STATE OF NORTH CAROLINA  
DEPARTMENT OF TRANSPORTATION

January 23, 2008

**SUBJECT:** 2001 Roadway Design Manual June Revision  
and New Guidelines for Revisions

## SHRINKAGE FACTORS

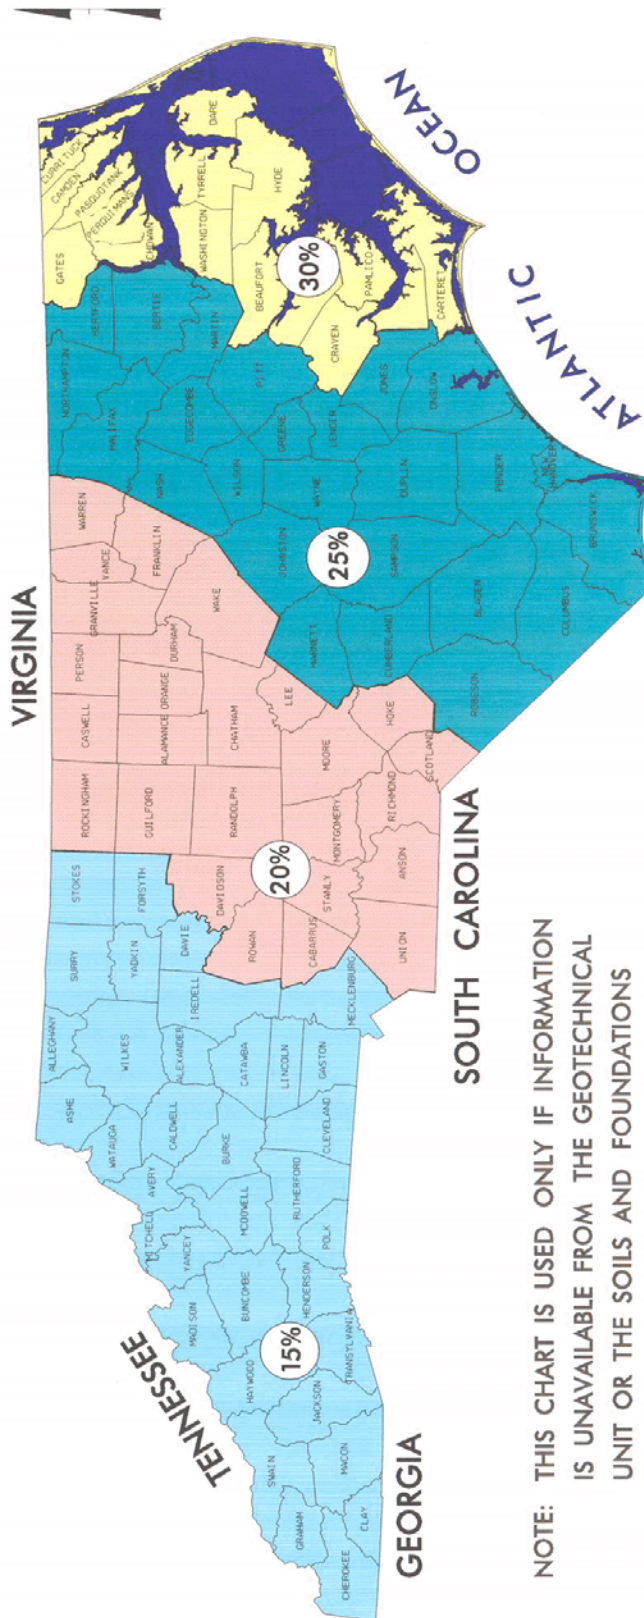
Note: Added Figure 1 reference to shrinkage factor info.

- B. Include recommendations from the Geotechnical Engineering Unit and/or the Soils and Foundation Section as follows:
1. Shrinkage Factor – (See Figure 1)
